KMR.CDD.JmQ.1937-1940.01

With reference to your application dated 20-5-38
with a plan for the proposed buildings/additions and alterations on plot
No. 27 Survey Sheet No. J.M.4, Jamshed Quarter,
I have to request you to comply with the following requirements:—

AMENDED PLAN SHOWING THE PROPOSED BUILDING

ON PLOT NO 27 J.M. 4 JAMSHED Q.R.

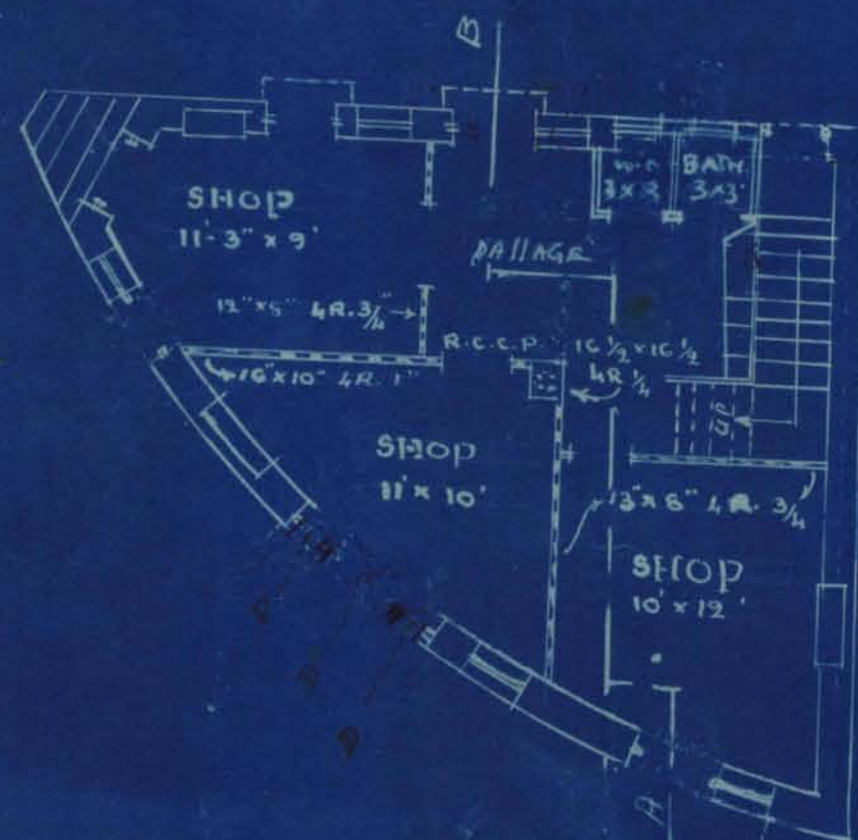
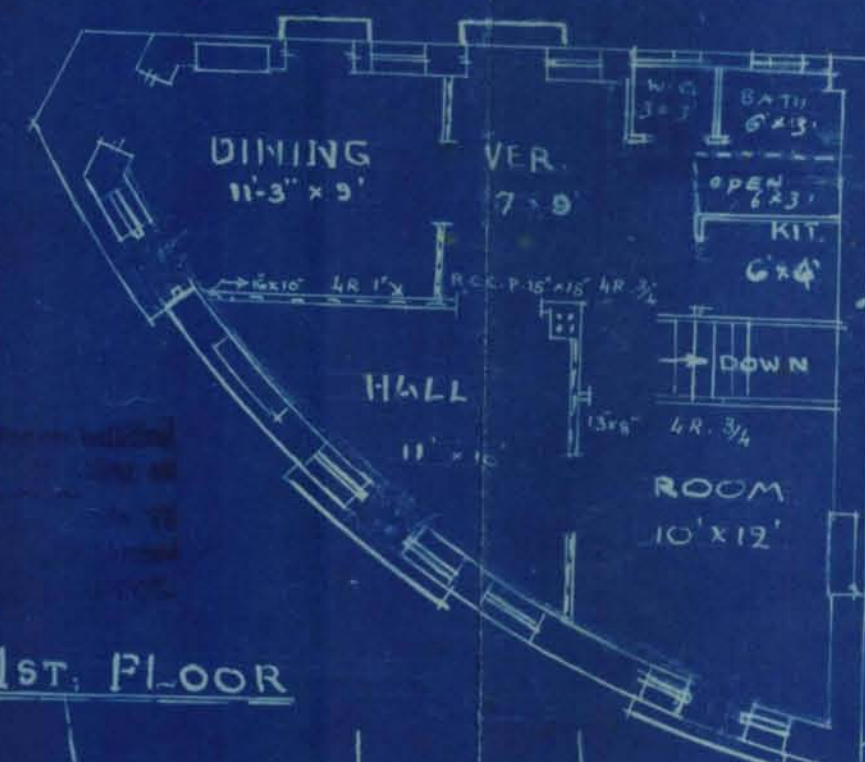
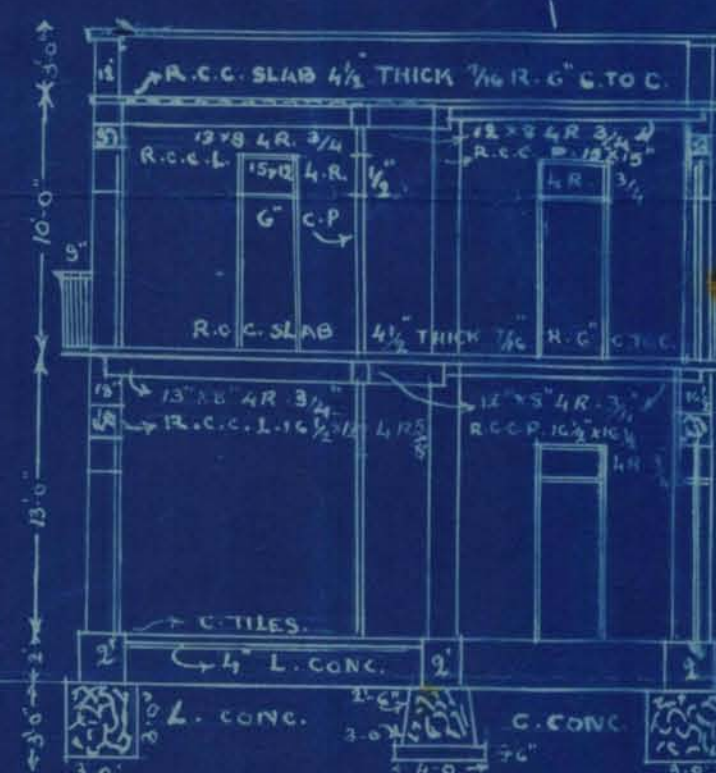
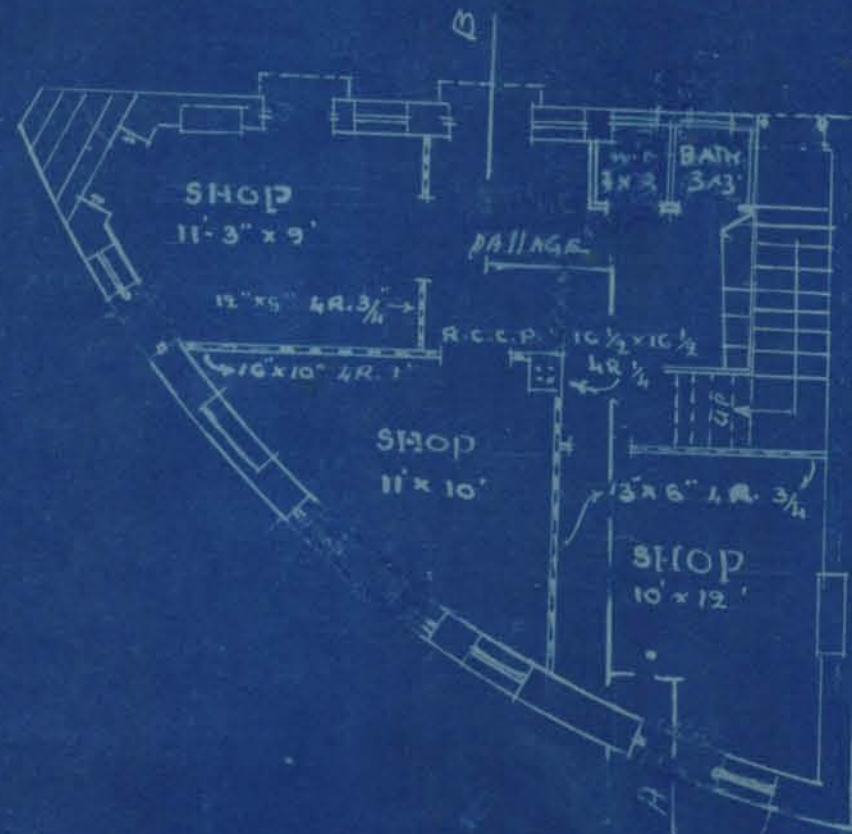
The ground floor has been tenanted to Mr. Roshanlal K.
and First floor to Mr. Ramchand Premchand. This can not be
allowed. The ground floor and first floor should be
occupied by a shop keeper. *The 1st floor should be
used for shop purpose only.*

the 9th floor has been tenanted to Mr. Rothaulal. K. and F.P. to Mr. Ramchand Pranchand. This cannot be allowed. The 9th floor and 1st floor should be occupied by a shopkeeper. 1/6.

AMENDED PLAN SHOWING THE PROPOSED BUILDING

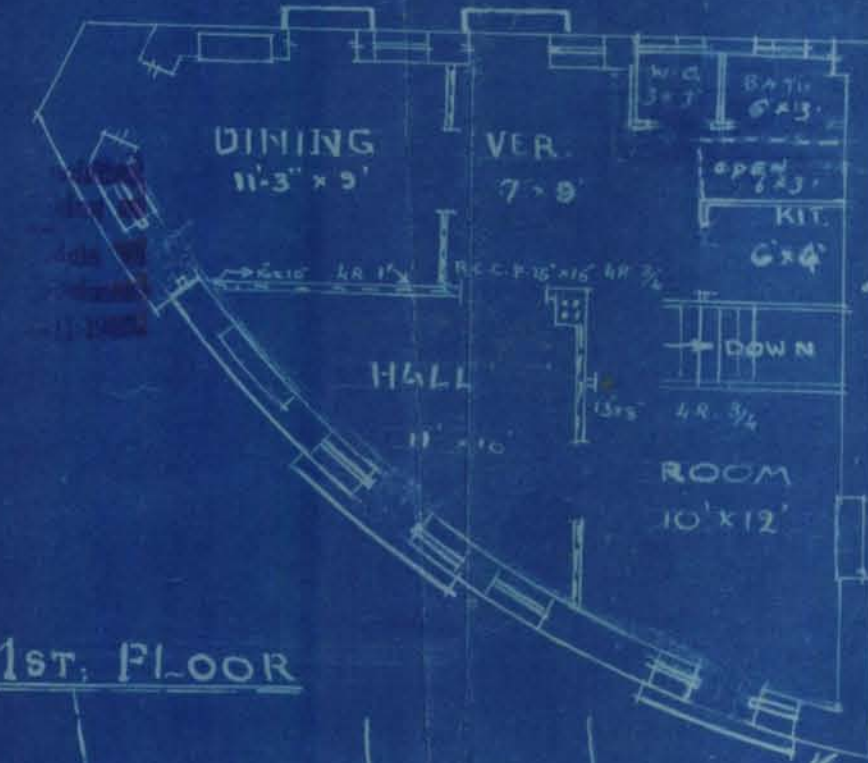
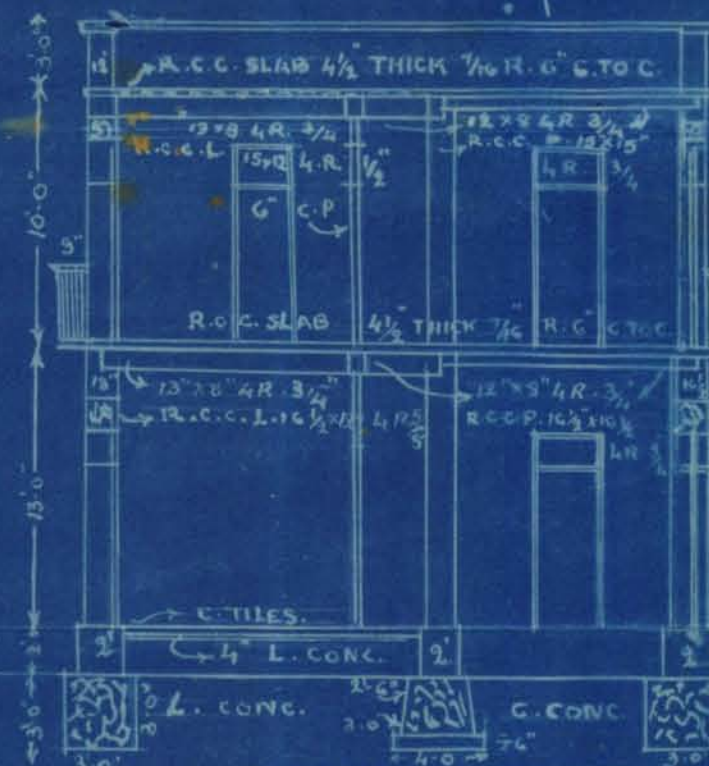
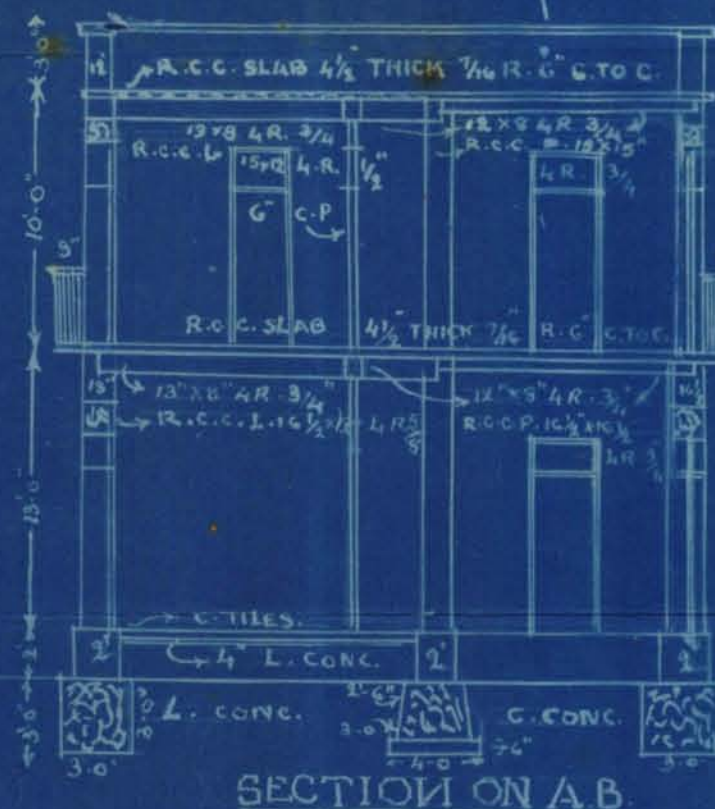
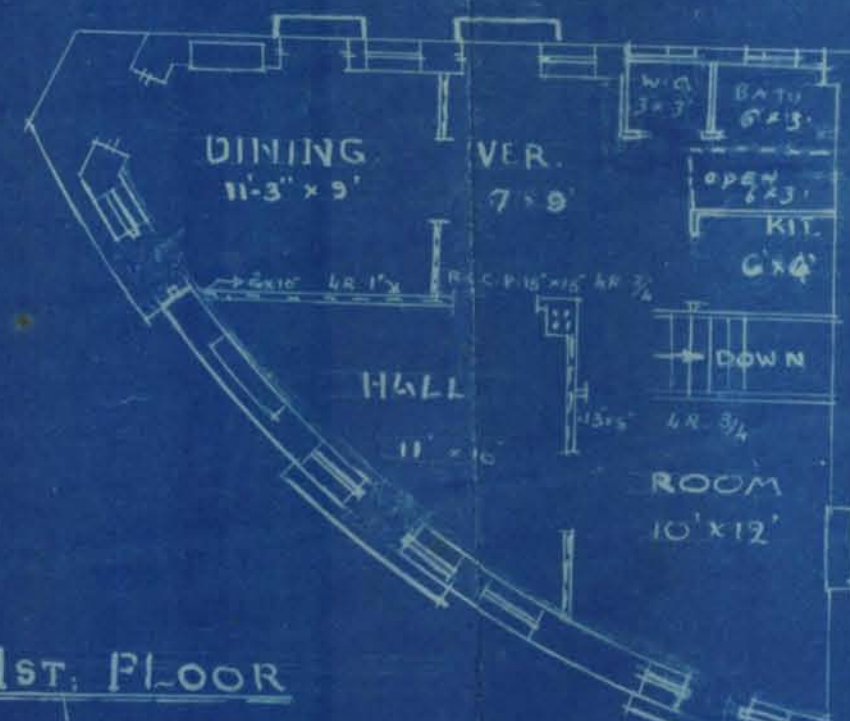
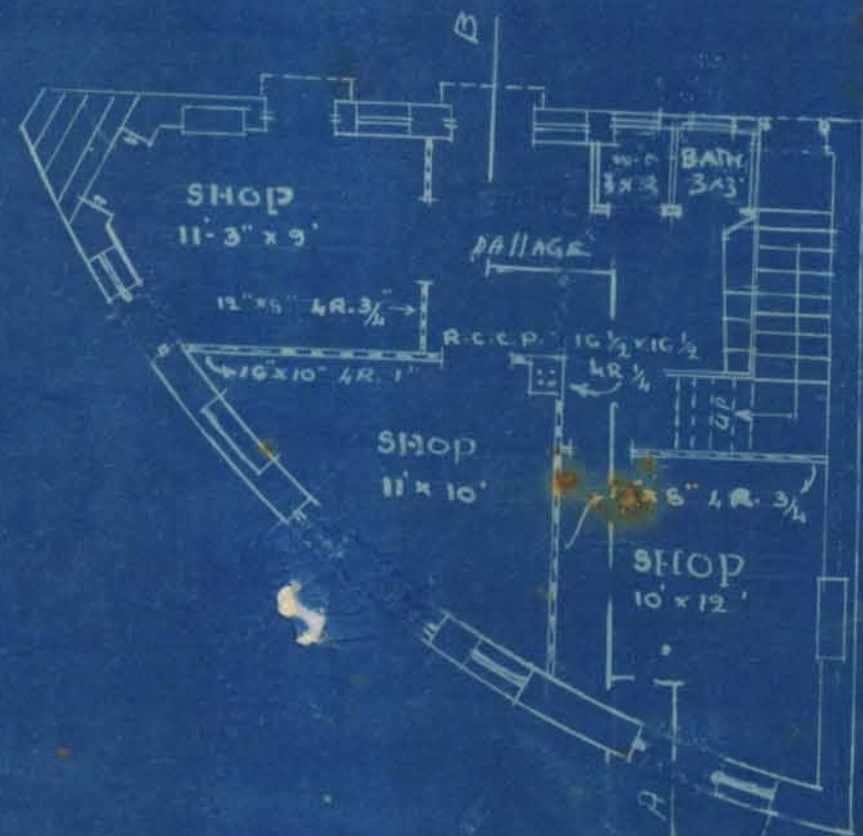
All the walls for the purpose of
partitioning shall be of
Standard 4" thick R.C.C.
work with 1/2" dia.
bars at 12" c/c.

AMENDED PLAN SHOWING THE PROPOSED BUILDING
ON PLOT NO 27 J.M. 4 JAMSHED QR.

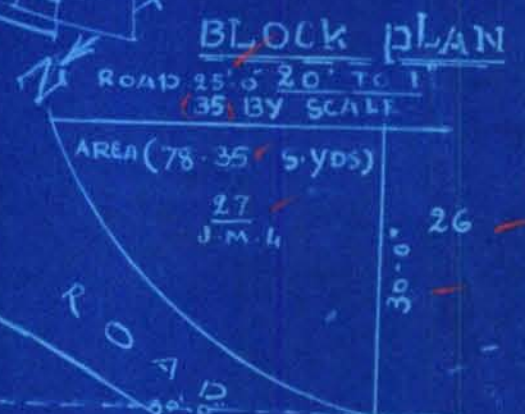
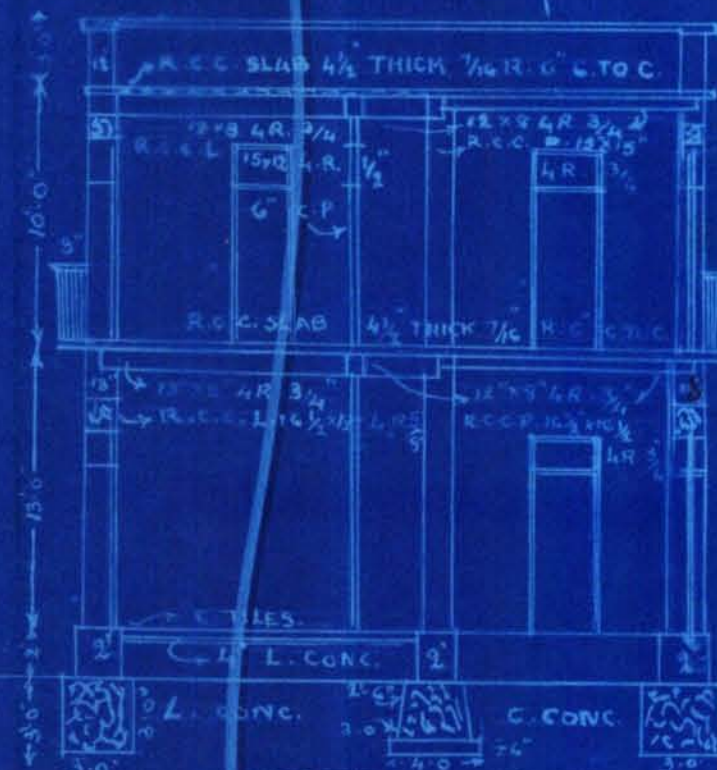
The doors as provided will not do. They should match
with those of the adjoining shops.

This should be sent in circulation 19/8
Notice will be done. The doors as provided will not do. They must match with those of the adjoining shops. 19/8
